UNITED STATES PATENT AND TRADEMARK OFFICE

APPLICATION NO.	FILING DATE	FIRST NAMED INVENTOR	ATTORNEY DOCKET NO.	CONFIRMATION NO.
10/576,935	06/20/2006	Guy Deneuvillers	13415/203014	9902

Office Action Summary	Application No. 10/576,935	Applicant(s) DENEUVILLERS ET AL.	
	Examiner ELANA B. FISHER	Art Unit 3733

DETAILED ACTION

Regarding the above claims, see figure 74 and the diagram provided below.

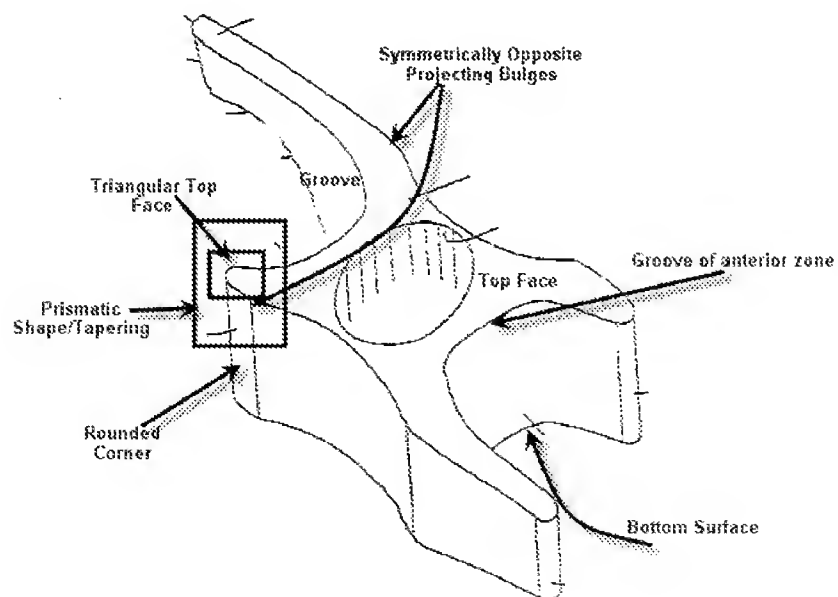
a. Regarding claim 22, Zucherman et al. disclose an intervertebral support comprising a spacer (702) and retaining means (710, 712, 714, 716), and being constituted by an anterior zone (708) suitable for being positioned between the laminae of the vertebrae, having the function of restoring an anatomical intervertebral spacing, and a posterior zone (706) comprising retaining means (710, 712) having the function of preventing the support from migrating towards the anterior portion of the spine by pressing against the lamina.

b. Regarding claim 23, the retaining means (710, 712) of the posterior zone (706) are lateral shoulders set back from the anterior zone and suitable for being received against the laminae of the vertebrae as close as possible to the articular facets.

c. Regarding claim 24, the retaining means (710, 712) of the posterior zone (706) are constituted by two transverse projections.

d. Regarding claim 25, the anterior zone (708) is provided with grooves (see diagram provided).

e. Regarding claim 26, the lateral shoulders (710, 712) are of small area being of the type having symmetrically-opposite projecting bulges (see diagram provided) set back from the anterior zone (708) and suitable for releasing movement of the vertebral articular facets.

f. Regarding claim 27, the anterior zone (708) is provided with grooves (see diagram provided), and the lateral shoulders (see diagram provided) have a height that does not exceed the height of the posterior zone (706) of the support, and are narrow in width.

i. Regarding claim 30, the posterior zone (706) is prismatic in shape (see diagram provided) and has a height that corresponds to the spacing between adjacent vertebrae, presenting at least one rounded corner (see diagram provided) with the top face of the posterior zone (706) being triangular in shape (see diagram provided), which makes it capable of receiving the junction point formed by the lamina and the processes.

j. Regarding claim 31, the tapering shape (see diagram provided) of the posterior zone (706) allows freedom of movement between the top face of the spacer (702) and the process above the region fitted with the implant.

k. Regarding claim 32, the posterior zone (706) presents a top surface and a bottom surface (see diagram provided) that are flared to the anterior end (708) of the spacer (702), tapering progressively towards the posterior ends of the surfaces, and capable of receiving the junction point formed by the lamina and the process.

n. Regarding claim 42, the top face of the posterior zone (706) presents a shallow groove (see diagram provided) extending lengthwise in its middle and suitable for coming into contact with the process above the region fitted with the implant.

Regarding the above claims, see figure 36 and the diagram provided below.

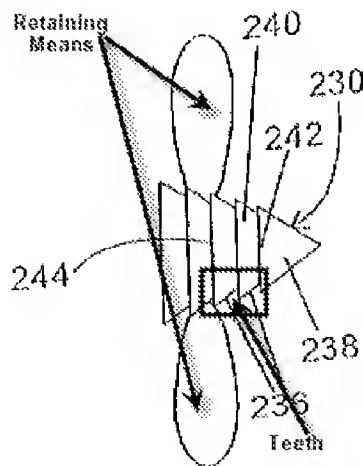
- a. Regarding claim 22, Zucherman et al. disclose an intervertebral support comprising a spacer (244) and retaining means (side wings; see diagram provided), and being constituted by an anterior zone (238) suitable for being positioned between the laminae of the vertebrae, having the function of restoring an anatomical intervertebral spacing, and a posterior zone (236) comprising retaining means (240) having the function of preventing the support from migrating towards the anterior portion of the spine by pressing against the lamina.
- b. Regarding claim 34, the core of the posterior portion (236) carries teeth spaced apart by furrows (see diagram provided), and opposed to each other in pairs on the bottom and top faces, enabling the flexibility of the assembly to be varied.

Regarding the above claims, see figure 37 and the diagram provided below.

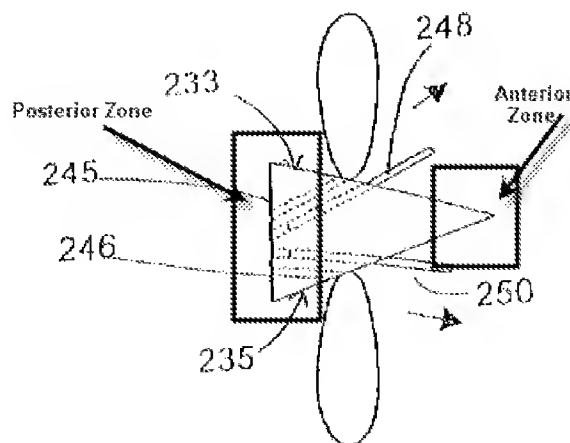
- a. Regarding claim 22, Zucherman et al. disclose an intervertebral support comprising a spacer (233) and retaining means (side wings; see diagram provided), and being constituted by an anterior zone (see diagram provided) suitable for being positioned between the laminae of the vertebrae, having the function of restoring an anatomical intervertebral spacing, and a posterior zone (see diagram provided) comprising retaining means (233, 235) having the function of preventing the support from migrating towards the anterior portion of the spine by pressing against the lamina.

- b. Regarding claim 40, the support further includes additional retention means constituted by ligaments (248, 250) crossing in the center of the implant, and holes (245, 246) extending vertically for passing the ligaments.

- c. Regarding claim 41, the support further includes additional retaining means constituted by independent ligaments (248, 250) passing through the full height of the support.
